**JP Research, Inc.**

February 15, 2013

Enclosed, please find my report evaluating the methodology and assumptions made by the JASIC (Japan Automobile Standards Internationalization Center) group and the Federal Highway Research Institute on the estimation of cost reduction due to tibia fracture mitigation. In particular, the results presented in the documents GTR9-5-14 Phase 2 and GTR9-5-19 are evaluated for the validity of the assumptions and the statistical methodology used. We do not address cost estimates and reduction in this report.

Figure 1. Percentage of Serious Lower Limb Injuries* that are Tibia Fractures

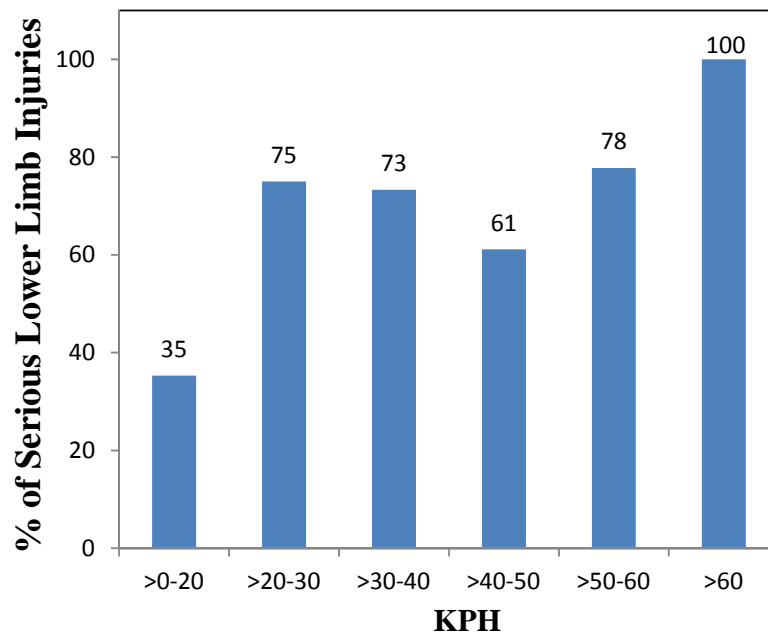
JP Research used the PCDS (Pedestrian Crash Data System) for the years 1994-1998 to determine the percentage of serious lower extremity injuries that were serious tibia injuries. There were 121 pedestrians with serious lower limb injuries (MAIS 2+, excluding fatalities) and of these, 75 (62%) were tibia fractures. But this 62% varied significantly across impact speed categories as seen in Figure 1.

For example, for the impact speed less than 20 KPH, 35% of serious lower limb injuries were tibia injuries, while for other speed categories over 60% of serious lower limb injuries were tibia injuries. The JASIC study used 66% across all vehicle speed groups which is not a valid assumption for converting lower extremity injuries to tibia injuries.

In addition, there were 69 pedestrians with MAIS 3-4 lower limb injuries, and of these, 56 (82%) were tibia fractures. Consequently, the percentage also varies based on injury severity and the JASIC study used 66% for all AIS 2+ injuries while making the conversion.

Figure 2. Percentage of Pedestrian Crashes by Difference between Travel Speed and Impact Speed

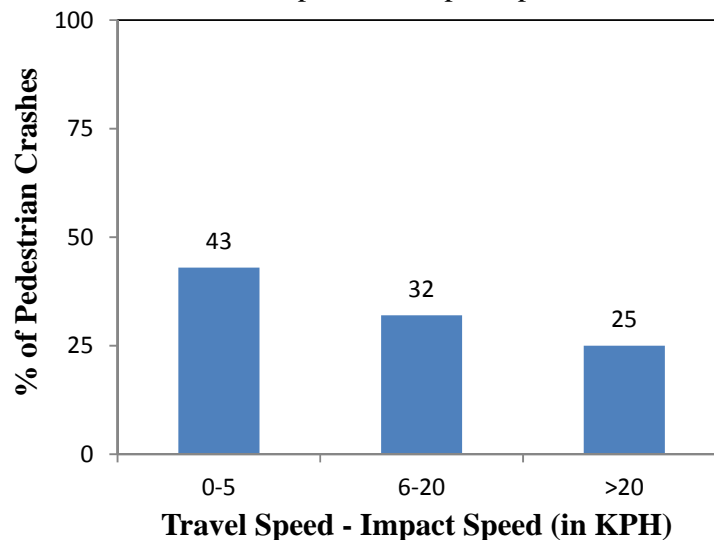
Figure 2 shows that in PCDS, only for 43% of crashes, the difference between impact speed and travel speed was less than 5 kph. For 32% of crashes the difference was 6-20 kph and for 25% of crashes, the difference was more than 20 kph.

Again, assuming a difference of 5kph between travel speed and impact speed is not valid and consequently, using travel speed to estimate impact speed is not a valid approach to estimate number of serious tibia injuries.

Figure 3. MAIS Injury Distribution for all Pedestrians

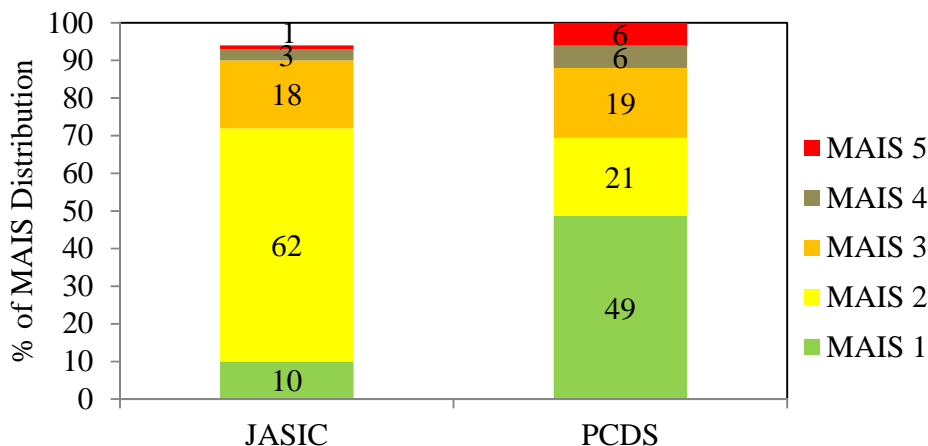
The cost reduction due to introduction of FlexPLI within GTR9 analysis was reviewed to compare the injury distribution for pedestrians involved in crashes in the US versus Germany. The injury distribution presented in this document used GIDAS. JP Research used PCDS data to compare the corresponding injury distributions to pedestrians in US crashes. As seen in Figure 3, the injury distributions were markedly different between GIDAS (German experience) and PCDS (US experience) and the results from Europe on pedestrian crashes and injuries may not be transferrable to US. In addition, the BAST (GIDAS data) study shifts injuries by AIS-1 (ex: AIS-2 is reduced to AIS-1, due to friendly bumper design) using GIDAS data and recalculates the national estimates of annual number of “slightly” injured and “severely injured” tibia injuries. This method assumes a relationship between AIS injury severity levels based on in-depth investigations and injury classifications reported by police reports which contribute to the German national accident data. For example, in the US, these two injury classification schemes (police reports versus NASS/CDS) are based on significantly different criteria and a simple transformation across these two distinctly different data bases is not done unless a probabilistic method of data linkage is used.
